SUBJECT: NuScale Power, LLC Response to NRC Request for Additional Information No. 9306 (eRAI No. 9306) on the NuScale Topical Report, "Rod Ejection Accident Methodology," TR-0716-50350, Revision 0

Response to Request for Additional Information Docket No. 52-048

eRAI No.: 9306

Figure 5-1 Control rod assembly layout for the NuScale Power Module

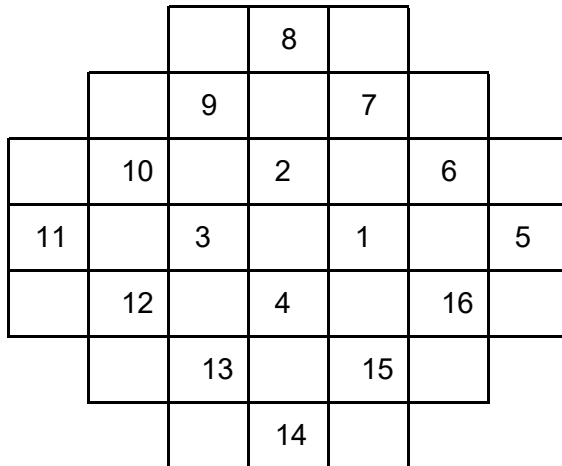
- a. Please indicate if the uncertainties in Table 5-1 will be updated consistent with TR-0616-48793. If the uncertainties will not be updated as discussed in TR-0616-48793, either describe the method for updating them or provide a justification as to why an update is not necessary. If the uncertainties in Table 5-1 will be updated, modify TR-0716-50350 to indicate the method by which updates will be made.
 - b. Justify the use of a lower $F_{\Delta H}$ uncertainty for the rod ejection analysis relative to the steady-state $F_{\Delta H}$ uncertainty.
-

- a. The uncertainties in Table 5-1 are updated as described in TR-0616-48793 (Reference 8.2.7) for all except the $F_{\Delta H}$ engineering uncertainty, which is updated consistent with the value in the Subchannel Analysis Methodology topical report (TR-0915-17564, Reference 8.2.11). The Rod Ejection Accident Methodology topical report (TR-0716-50350) was revised as indicated in the markup provided with this response to define the method in which the update is made. The title of Table 5-1 was also revised to
-

The core is designed with quadrant symmetry, where CRAs 1, 5, 15, and 16 in Figure 5-1 represent all unique CRA positions in the core. Only the CRAs in the regulating bank are eligible for ejection and considered in the REA methodology.
